Preliminary Consultation
MONTGOMERY COUNTY HISTORIC PRESERVATION COMMISSION
STAFF REPORT

Address:	7417 Baltimore Ave., Takoma Park	Meeting Date:	10/14/2020
Resource:	Contributing Resource Takoma Park Historic District	Report Date:	10/7/2020
Applicant:	Brock Merwin	Public Notice:	9/30/2020
Review:	Preliminary Consultation	Staff:	Dan Bruechert
Proposal:	Porch Alterations

The applicant proposes to reconstruct the existing front porch.

A1.1

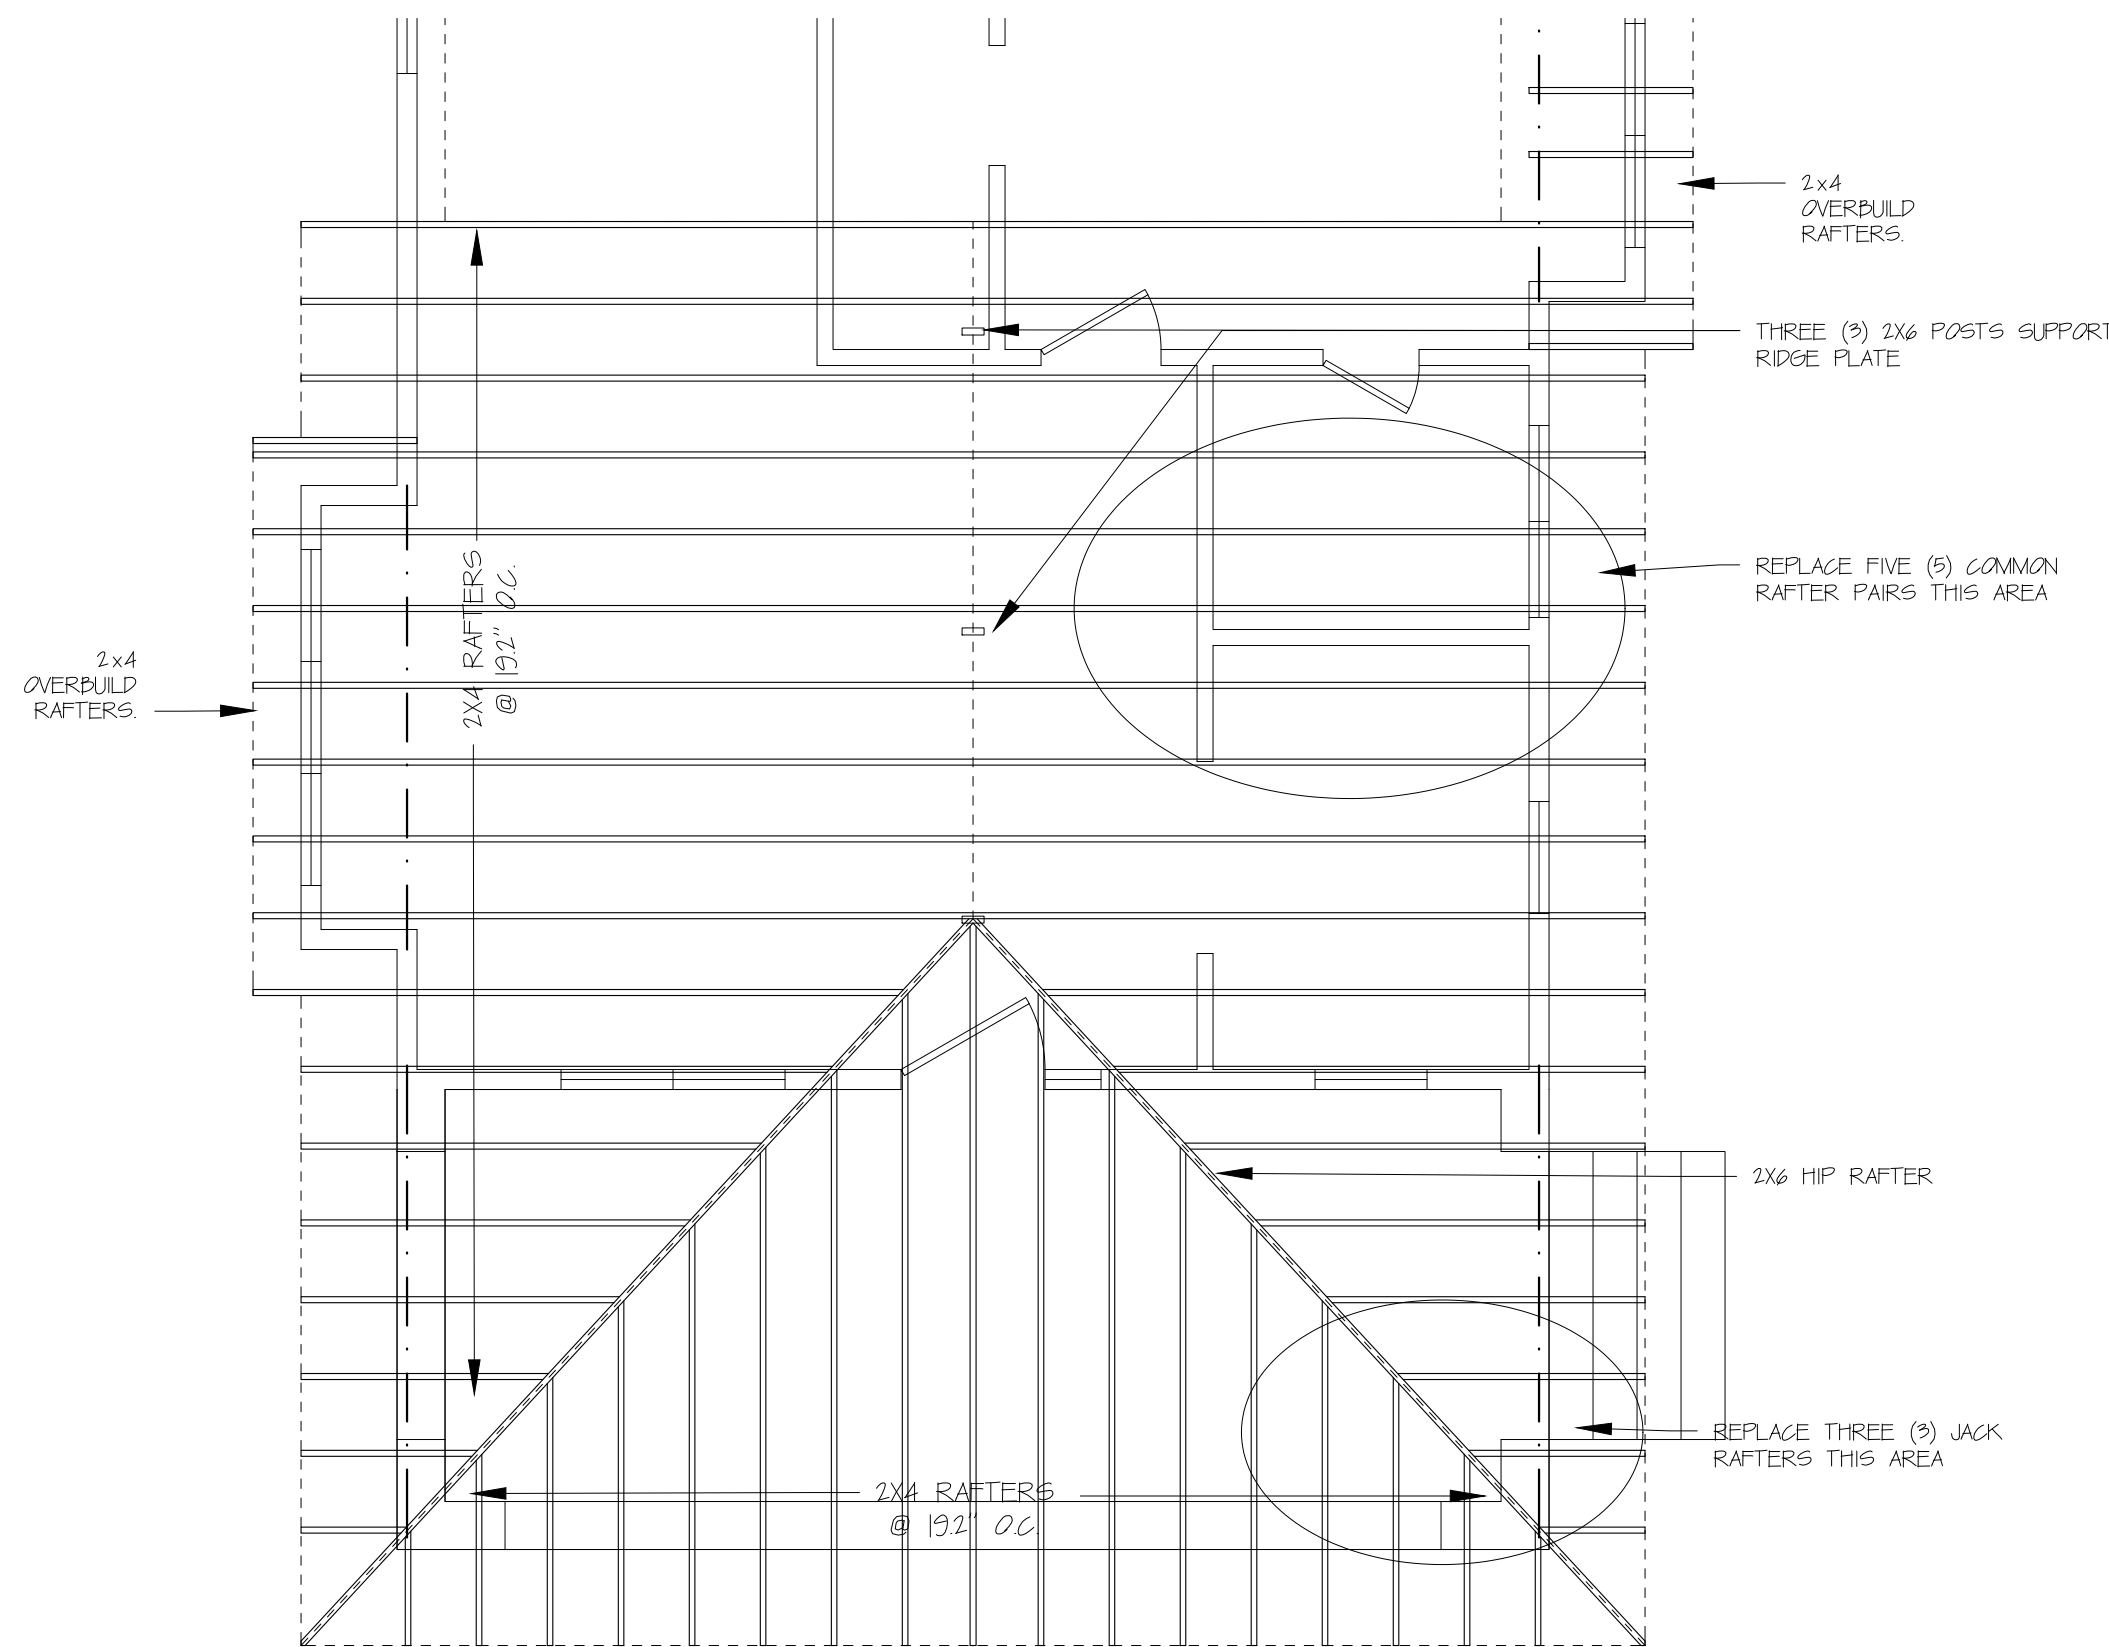
Staff finds that the form of the front porch is one of the few remaining historic elements remaining on the house. Staff finds that installing a gable roof on the front porch could be “generally consistent with the predominant architectural style and period of the resource” however, it would not “preserve the predominant architectural features of the resource” per the *Design Guidelines*. The proposal appears to be detailed more like a Craftsman-style modification, typically found throughout the neighborhood. Should the HPC determine that the front porch may be altered as proposed, Staff recommends that the design of the front gable be altered to be more compatible with the building style; namely that the gable project beyond the new wall plane, matching the overhang found throughout the house, and that the fiber cement siding is replaced by stucco to match the first floor of the house.

On the right side of the house, the applicant proposes removing one window, repairing the damaged wall, and installing a new window matching the dimensions of the taller front windows. Window specifications were not included with the submission. Staff finds that the damage to the wall needs to be replaced and much of that work is repair in-kind. The *Design Guidelines* state that “Original size and shape of window and door openings should be maintained, where feasible.” Staff finds that changing the window size is incompatible with the *Design Guidelines* and recommends the HPC require the replacement window be installed in dimensions matching the existing. Window specifications need to be submitted with the HAWP application.

A1.3

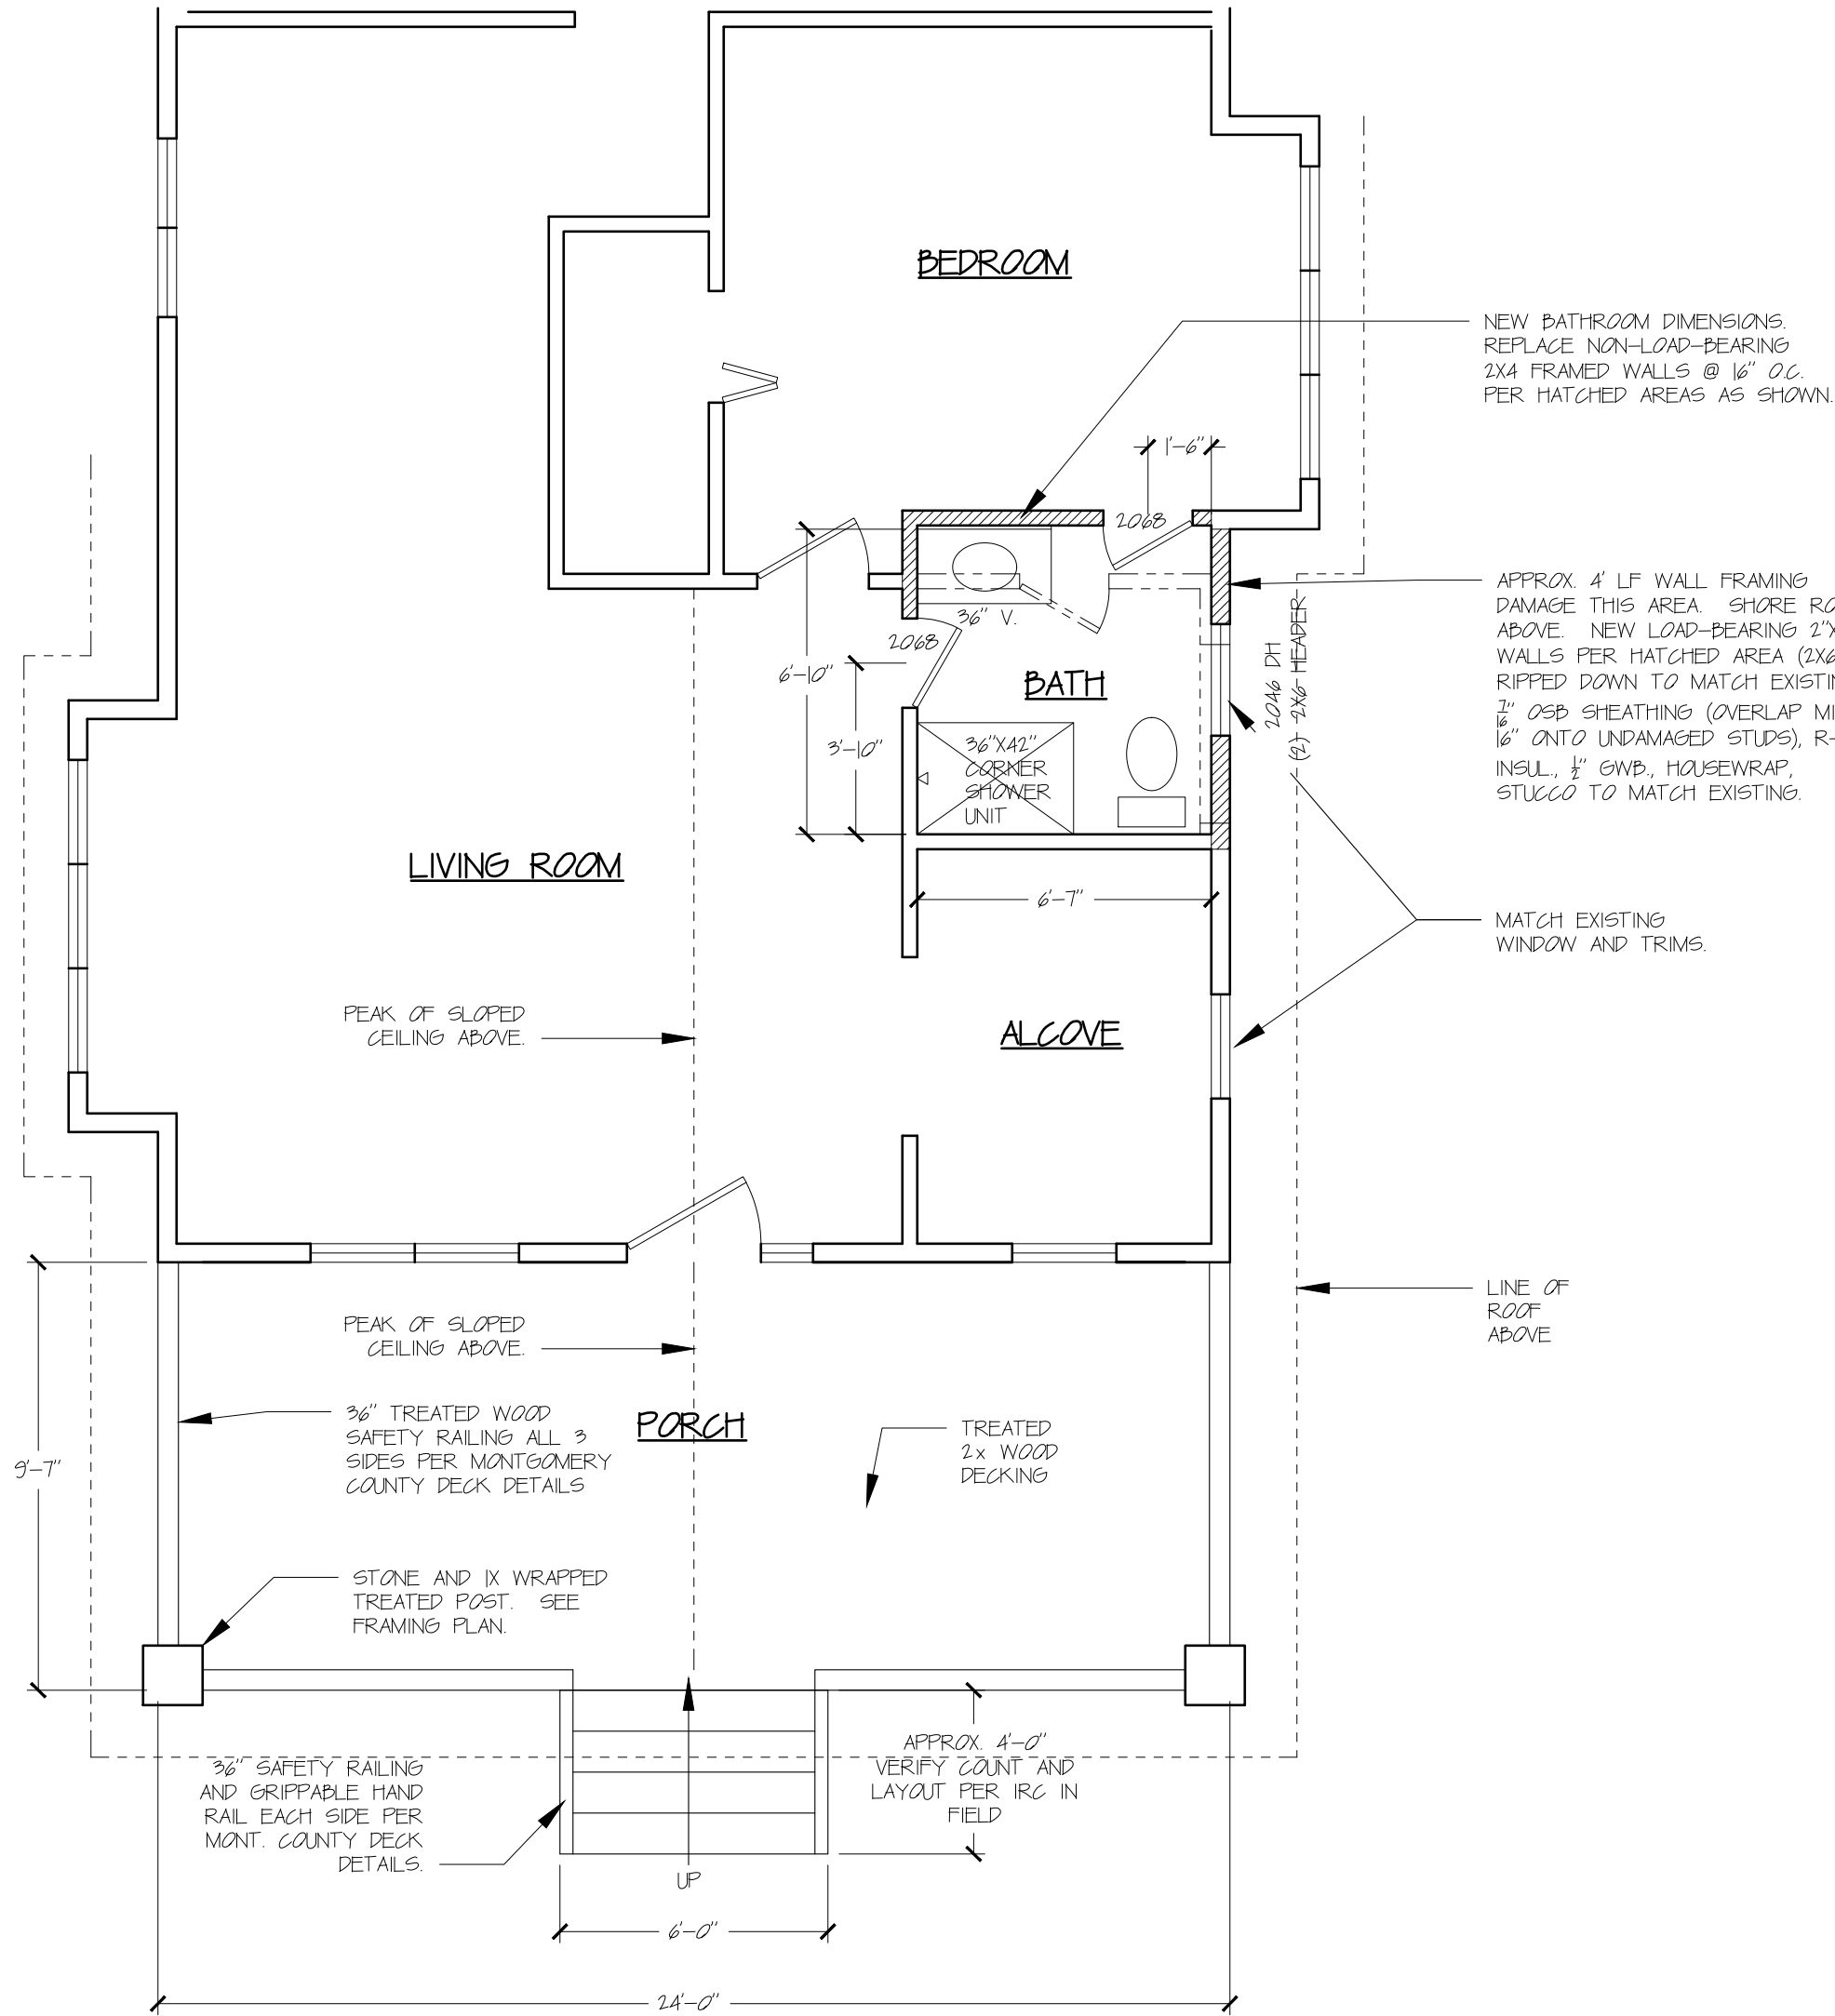
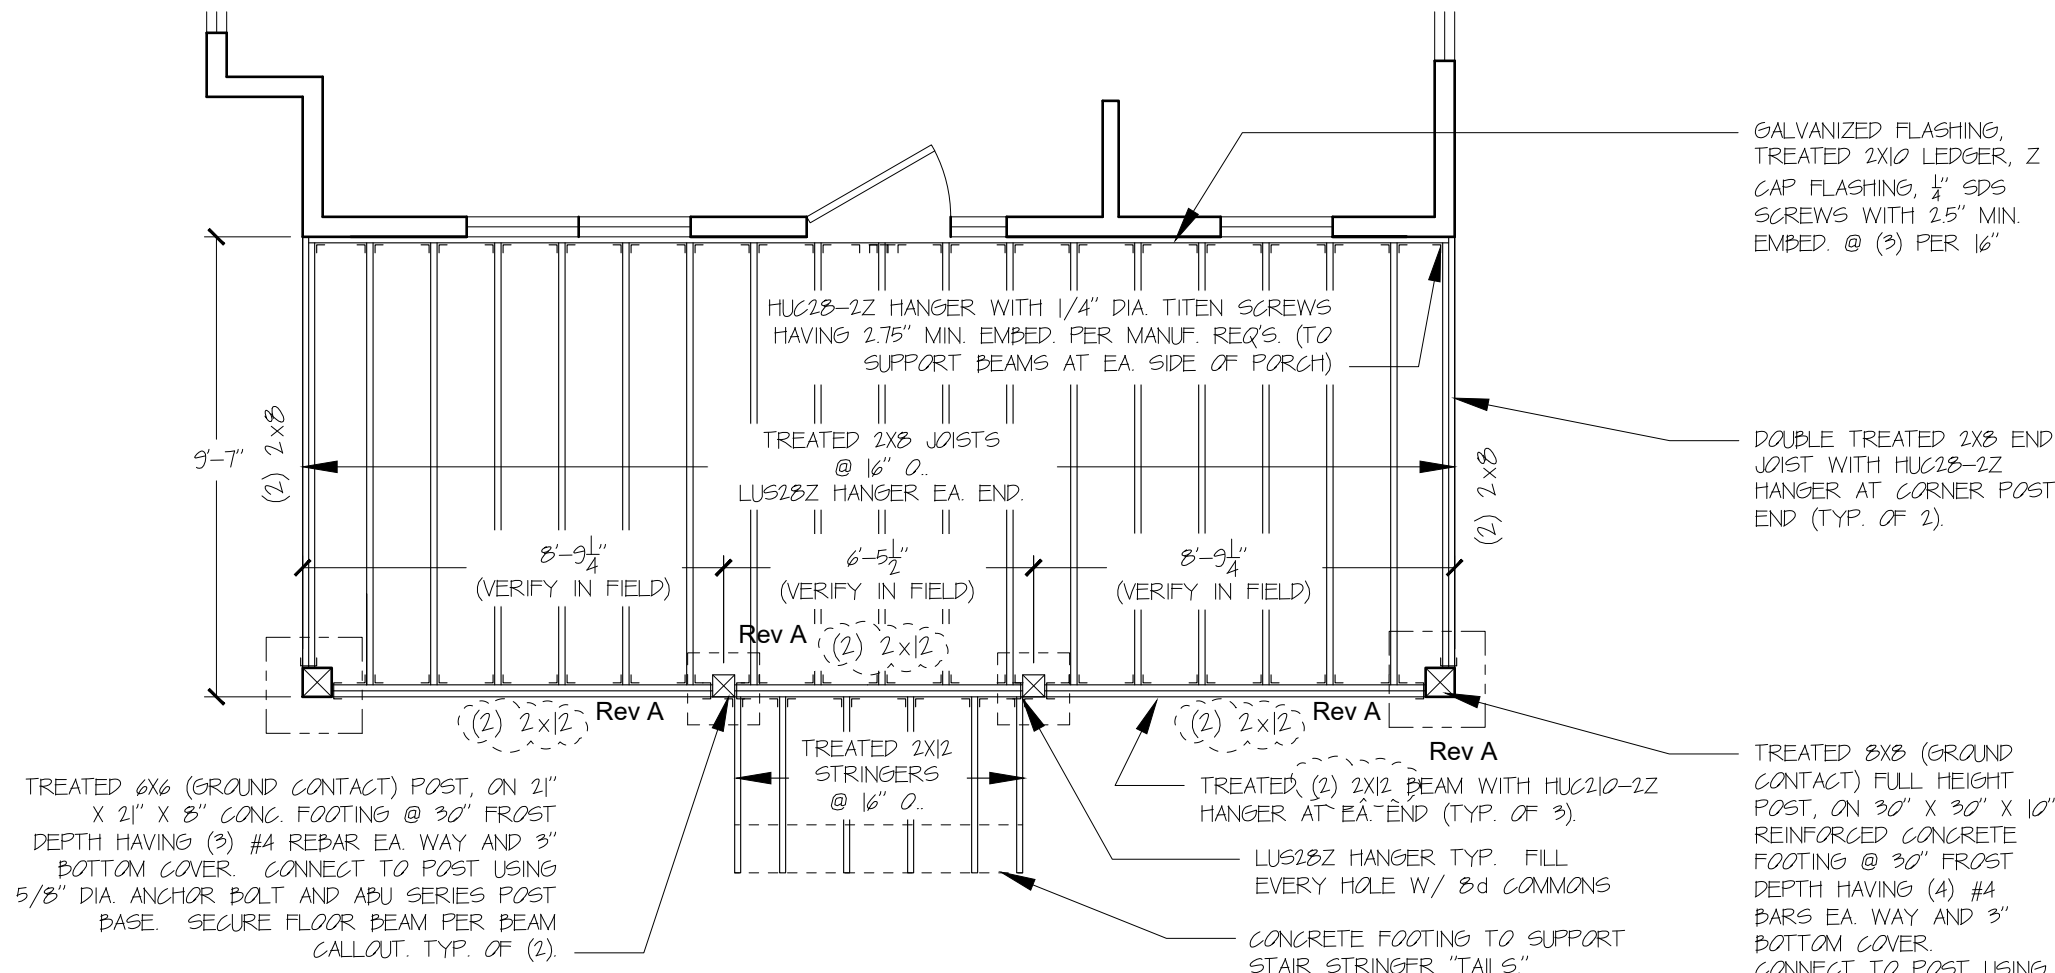
The second change proposed is to “open up” the front porch and remove all of the stucco above the floor surface and install new battered columns to support the porch corners. This includes the knee wall and the front arch under the eave. The columns will have stone veneer bases and wrapped battered columns. Columns similar to the one proposed are occasionally found in Prairie-style architecture, but Staff is concerned that introducing another material to the house would create an incongruous appearance. The house has a painted brick and concrete foundation and stucco siding and fiber cement siding. Staff finds that, should the HPC determine the new columns are appropriate, the HPC should require the column bases to use a material already found on the house; Staff’s recommendation is either painted brick or stucco.

The third proposed change is to remove the existing side-loading concrete stairs and install a set of wood, front-loading stairs. The *Design Guidelines* emphasize the importance of the resource to the surrounding streetscape and in this case, virtually every other house has front-loading stairs. The information submitted does not provide much more detail than the stairs will have a concrete footing to support the stringer tails and that there will be a railing, per County Code, but does not include detailed specifications. Staff requests the HPC provide feedback on the appropriateness of relocating the entry stairs and design/material specifications to make the design more compatible.

- Railing specification were not included with the submission, including areas where the existing knee wall are proposed for removal. Because of the style and materials of the subject property, a typical open wood railing would likely be inappropriate.
- The proposal to install front-loading stairs did not include any information about a new walkway. How will this feature be treated with regards to walkway placement and dimensions, material(s),

re-grading, etc.? Additionally, what is proposed for the existing sidewalk and stairs?
